Guildford Environmental Forum Response to Planning Application to discharge

Condition 4 The Landscape and Ecological Management Plan

Figure 4.1 Tree protection plan with areas proposed for removal in red

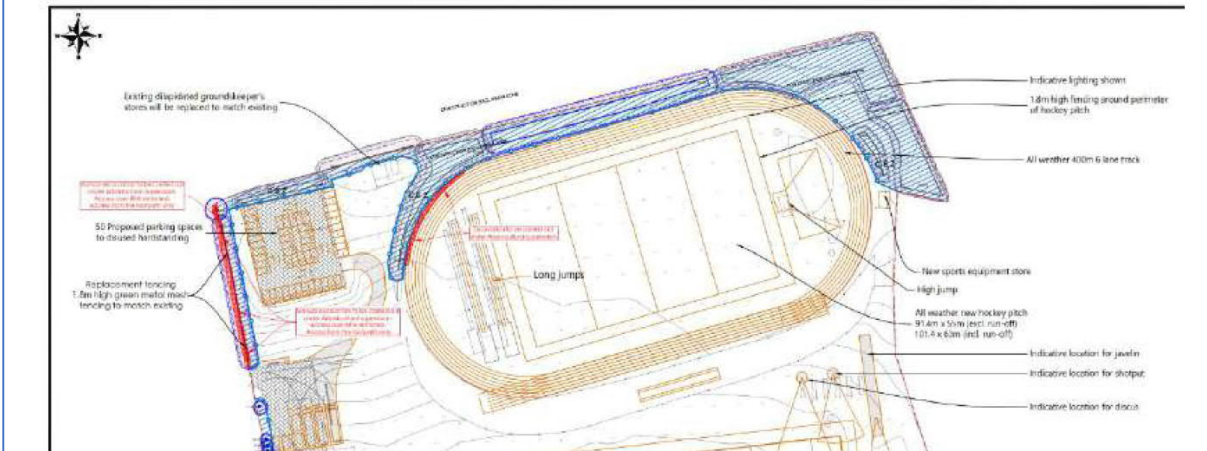
Figure 4.1 from 'The Landscape and Ecological Management Plan' clearly shows the location of the protected woodland shaded in blue on the plan below. This shows the woodland to be retained extends into the site as far as the edge of the proposed running track.

Figure 4.3 Image from the lighting report detailing Lux spill upon the woodland edge

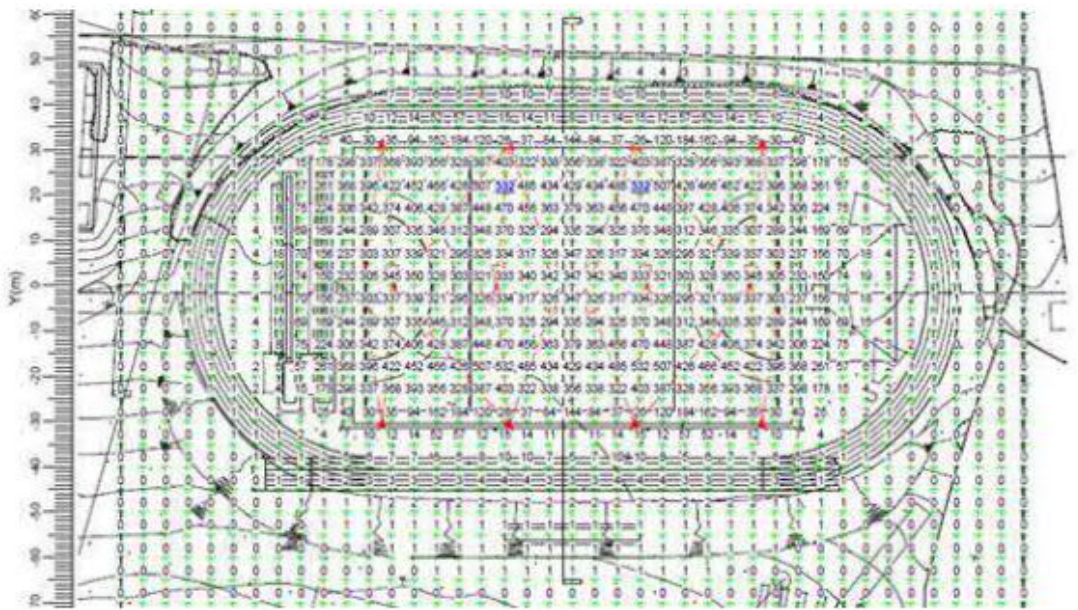
This figure demonstrates the level of light spill is approximately 1 lux onto the woodland edge which is equivalent to twilight⁵.

Throughout this process we have identified the technical flaws with the lighting analysis which still remain. The analysis submitted to date are designed to define the lux levels on the playing surface and not the impact on the surrounding environment. These calculations only look at pitch levels, not only do they ignore the wider impact on the trees but there is also no assessment or calculations for the light reflecting off the pitch surface.

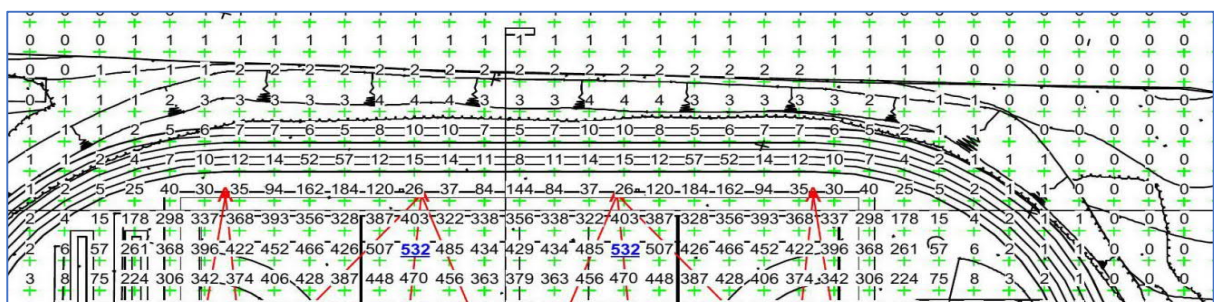
Even using these lighting levels and the information submitted, the LEMP has incorrectly identified the edge of the woodland as the edge of the site. We have provided a zoomed section of the figure below (from the LEMP) which identifies that the lighting proposal shows a figure of between 4 and 10 lux at the woodland edge and not 1 as claimed by the LEMP.

- The Lux levels at the woodland edge are between 4 -10 times the light level the design is seeking to achieve
- The design does not comply with Surrey Wildlife Trust 's requirement for no net increase in artificial lighting at the woodland edge

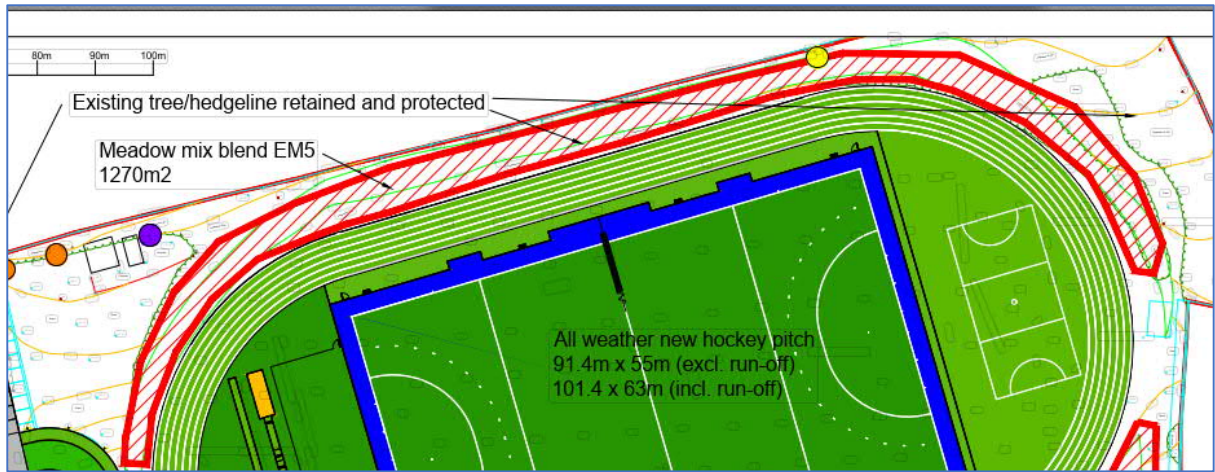
1. The surface water design highlights that Pesticides/Glyphosate will be used on the Astro turf areas and the LEMP does not explain how the conflict with using these chemicals and the damage they do to the natural environment on the boundary to a Site of Nature Conservation Importance.
2. the scheme talks about enhancement of the habitats and providing wildflower meadows of 3700m² of additional habitat. We would question the actual deliverability of this enhancement and request that the council carefully check these locations and would question if the design team have been to site. An example of this is 1270 m² of enhancement is located on a steep north facing slope within the retained woodland, therefore it is unsure how this will become a wildflower meadow (see extract of plan below).
